1-C-21-HZ
APPLICATION FOR CERTIFICATE OF APPROPRIATENESS

2057 Emoriland Blvd. 37917
Fairmont-Emoriland NC

Staff Report

File Number: 1-C-21-HZ

Rear Elevation

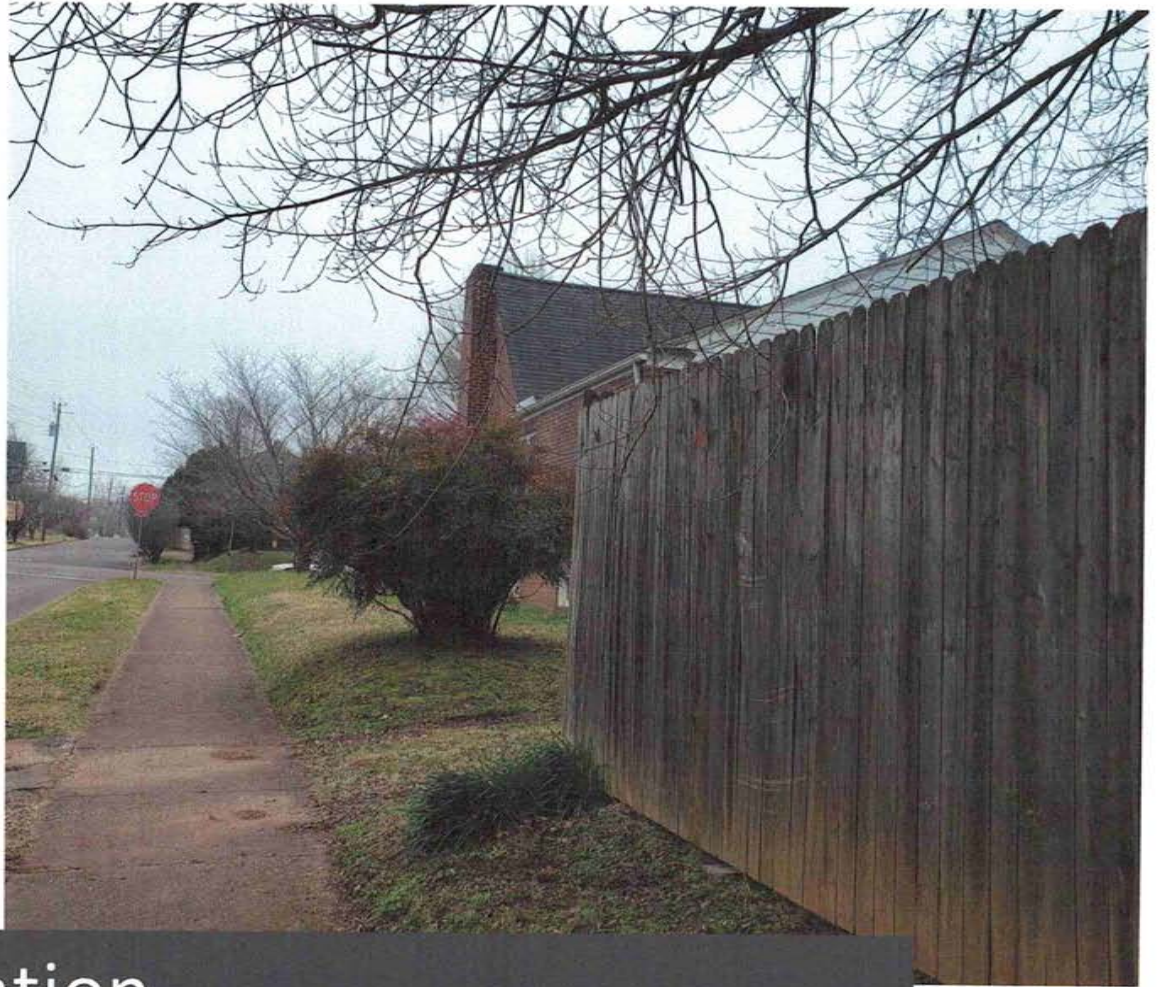
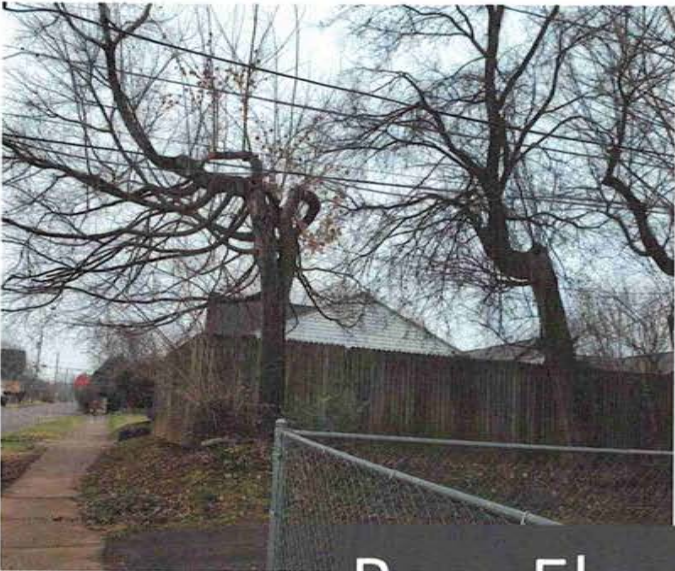
3. The primary residence is a Colonial Revival-influenced Minimal Traditional, with a simple brick masonry exterior, double-hung wood windows, and a wood-sided rear gable. The porch uses a simple design and materials that are complimentary to the primary residence. The 7/12 porch roof is compatible with the house.

5. At the December 2020 Historic Zoning Commission meeting, the application was approved with the condition that the porch gable be enclosed with siding to match the rear elevation's gable field (instead of the open gable detail as submitted). This condition was added based on the prominent location of the porch, and the guidelines that "the design of additions should be consistent with the character of the main structure" and "cladding materials should duplicate those on the existing house, or as shown on the matrix." The cladding materials listed under Minimal Traditional on the matrix are "brick, stone, weatherboard" with "wood, brick, wrought iron columns" listed as appropriate porch trim.
-

Staff recommends approval of the porch addition, including the installation of two new multi-light French doors, providing for discussion and conclusion between the Commission and applicant on the porch gable detail.
